170 Slater Street

UDRP Report and Response to UDRP Recommendations
April 10, 2024

**RE: Urban Design Review Panel Recommendation Responses
PC2023-0379
170 Slater Street – Site Plan Control**

Proposal for the north side facade in the interim period between phase 1 and phase 2 - final design to be determined

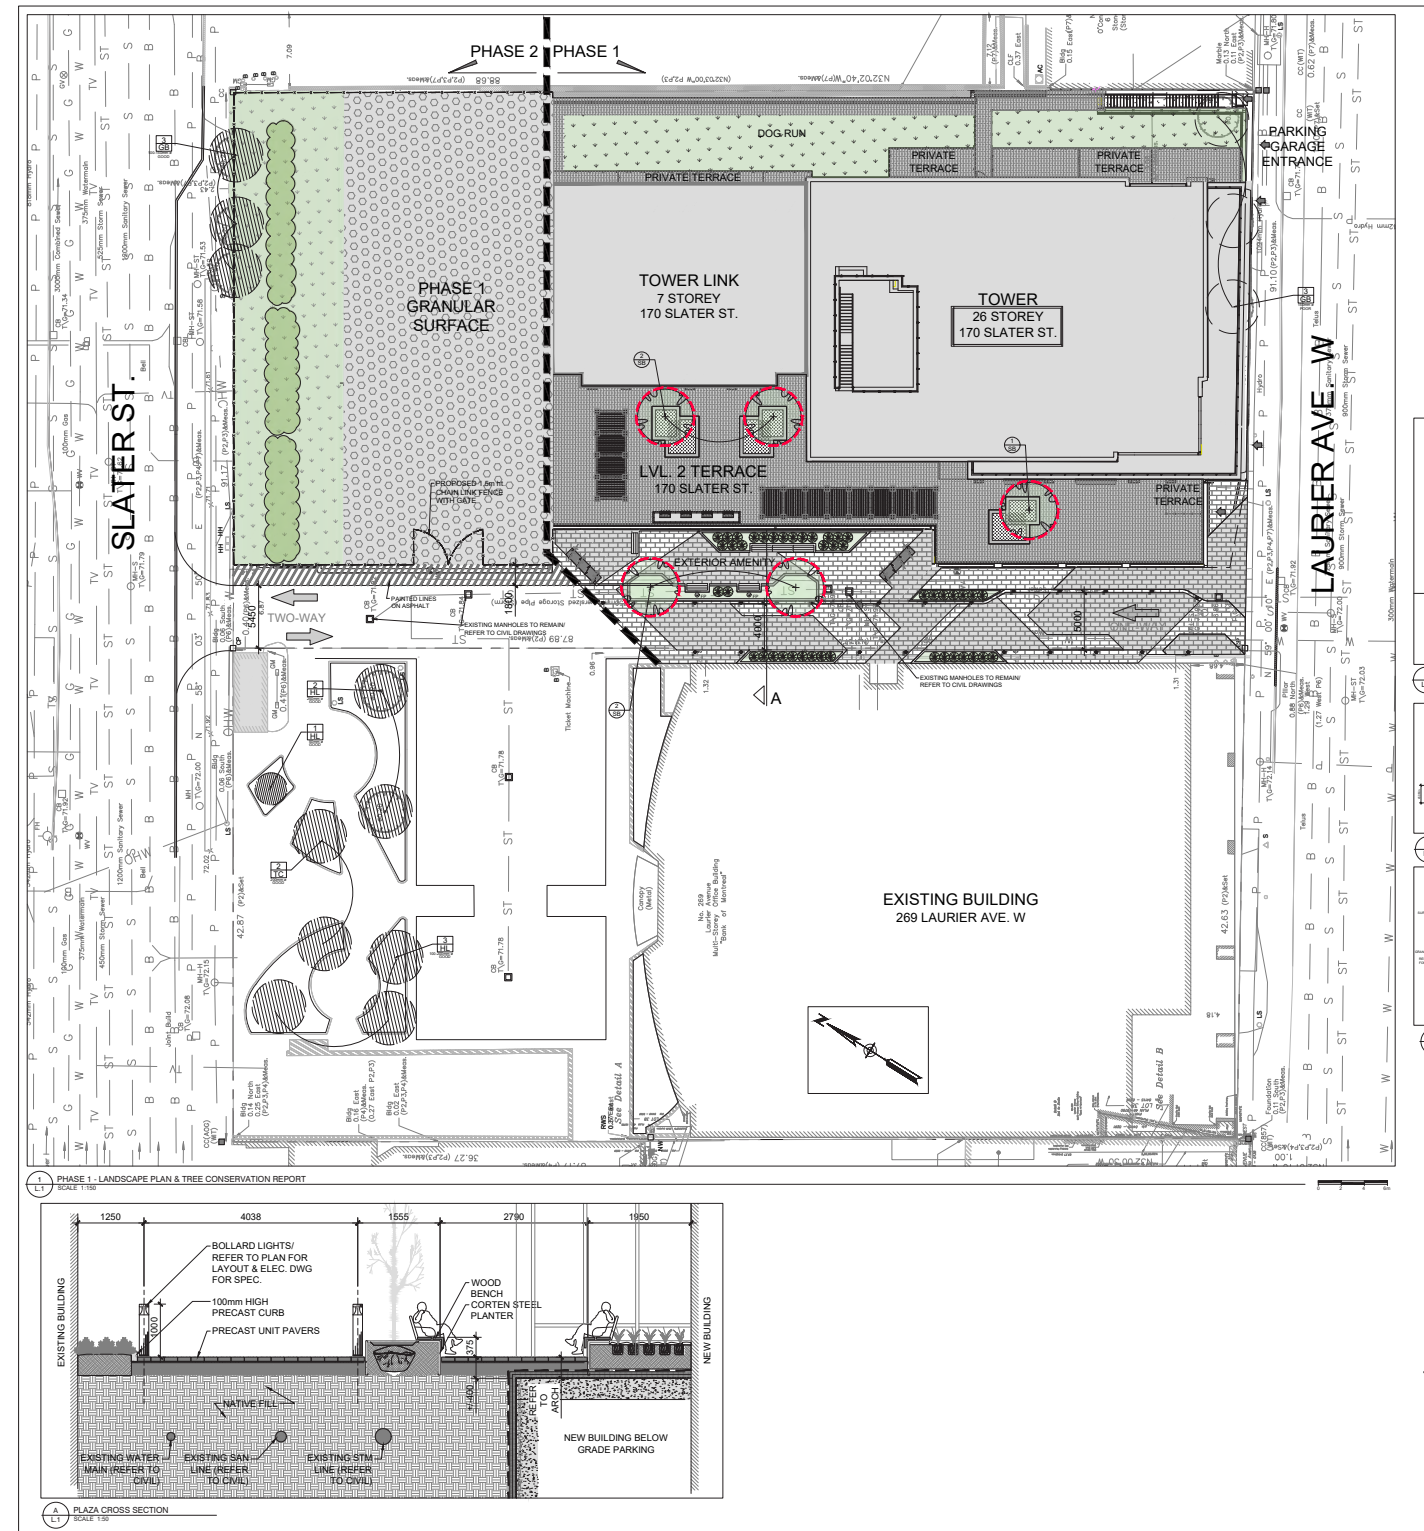
- 8 The Panel recommends carefully considering the interim period between the first and second phases of development in terms of how interim facade conditions and the at-grade areas are treated/animated.
 - / Consider a phasing strategy that enhances the spaces in the interim, such as having an art wall on the north side and a temporary POPS.
 - / Consider options other than surface parking for the interim landscaping phase.
 - / The Panel supports the idea of adding a large mural, that idea would mesh well with a public open space.

- 11 The Panel recommends extending the woonerf treatment of the laneway all the way to the edges of the site, and temporarily extending the linear parkette at the north-west corner into the future Phase 2 location to provide an interim POPS.

The north side façade has been revised to incorporate a large art wall that enhances the public experience in the open space facing the parkette and creates an environment conducive to urban life. The surface parking planned during phase 1 has been revised to add a landscaped buffer on Slater Street and by maintaining the existing trees on the northeast corner of the site. Temporary urban furniture can be incorporated in conjunction with city objectives in this area.

Zoom - Ground floor vehicular access from Laurier

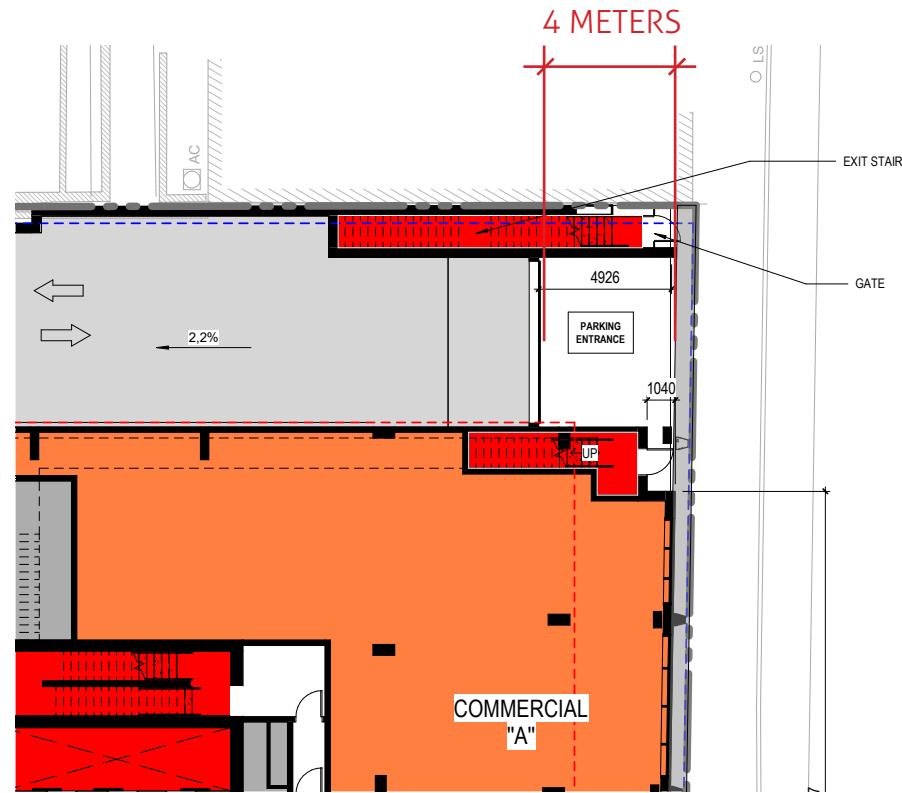
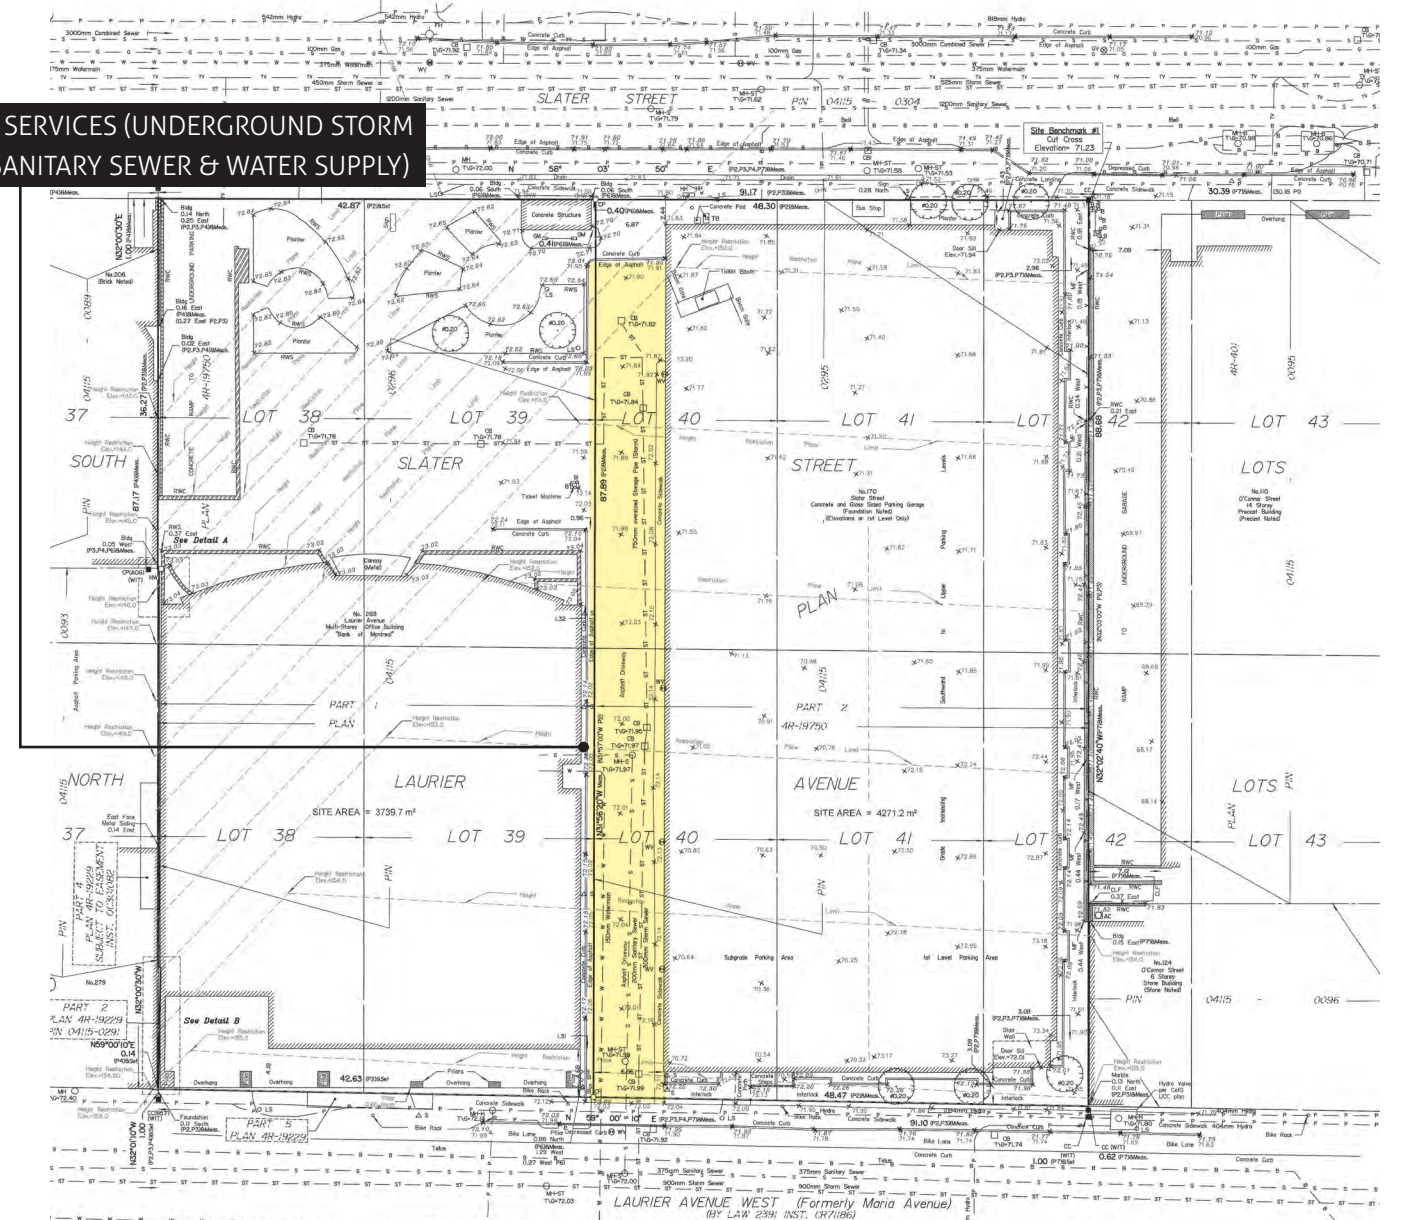
- 7 The Panel has concerns with the access to the parking garage and the complexity of frequent vehicular crossings over the bike lanes.
 - / Consider consolidating the parking access with the existing parking access off Slater Street for more efficient use of space.**Locating parking for the proposed development with egress/ingress from the existing parking access area would create more vehicle-pedestrian interactions in the woonerf area, which we view as not preferable.**

- 10 The Panel has concerns with the vehicular entrance from Laurier Avenue and its interaction with the existing westbound bike lane.
- / Consider sharing the existing parking ramp with the adjacent building and consolidating them as a single vehicular entrance to minimize curb-cuts and reduce intersections with the bike lane.

The vehicular access from Laurier is set back from the bike lane. We are leaving a 4 meter buffer zone between the garage door and the bike lane to ensure sufficient time for cyclists and motorists to see one another as they approach. Using the BMO parking ramp to access the new residential project is not possible as there are many existing services (underground storm sewer, sanitary sewer and water supply) under

the shared lane and there is insufficient height within the parking garage to accommodate delivery vehicles. Placing the access ramp next to the neighbor's ramp to the east on Slater would result in an overly wide curb cut which is unsafe for pedestrians. The fact that there is a dedicated bus lane also precludes creating another curb cut.
